- Preliminary Tree Protection Plan -

**BRITTON NORTH**

2365 Shady Lane Ct. NE  
Lacey, WA 98516

Prepared for: Lacey Community Development  
Prepared by: Washington Forestry Consultants, Inc.  
Date: December 7, 2021

## Attachment 2. Britton North Site Plan

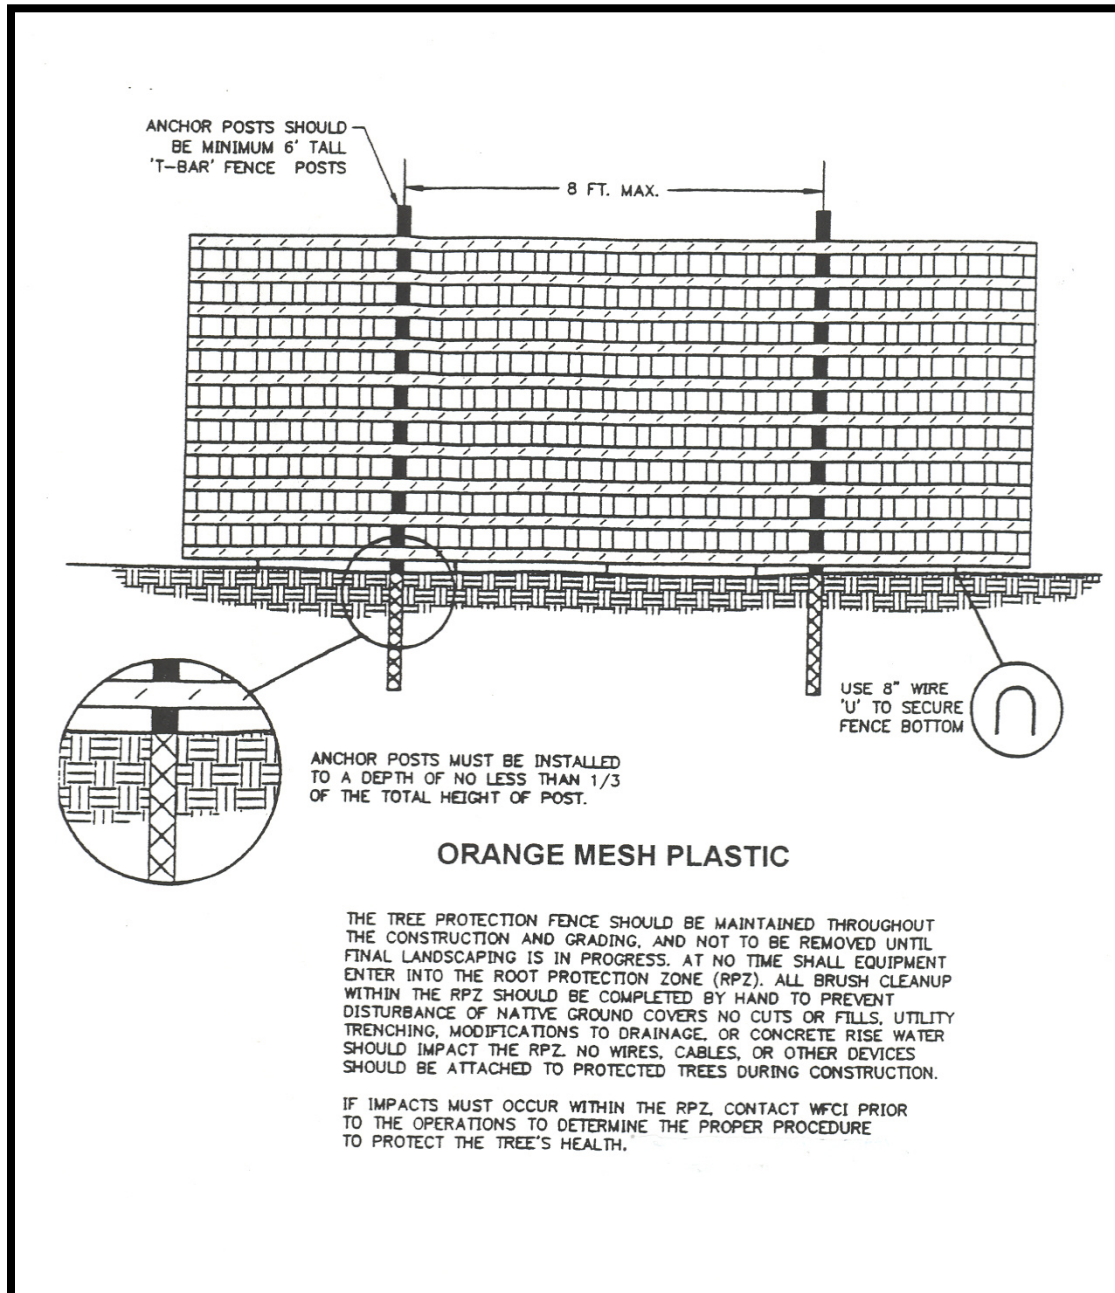
**The site plan does not show a dedicated tree tract area. It needs to be shown on the site plan and the area calculated.** It must be outside of the wetland and buffer on the site.

Update the site plan to show the required 5% tree tract. WFCI will then update the tree protection plan. Then submit ‘tree protection plan map’ on the face of the grading plan to the City of Lacey for approval. The tree plan map should include the tree tract boundaries, the locations of tree protection fencing, a tree protection fence schematic and this ‘Timeline for Tree Protection Activity.’ The tree protection plan map should be part of the construction drawings packet sent out to contractors for bid.

The project proponent is planning on developing a multi-family complex on 13.34 acres of a 29.64 acres parcel in Lacey. While the project buildable area is substantially treed, the intensity of grading and improvements will make tree retention challenging. **The site plan does not show a 5% tree tract. This area needs to be delineated on the site plan and a replanting plan developed if it is not already trees, or needs additional tree planting to meet the Lacey code.**
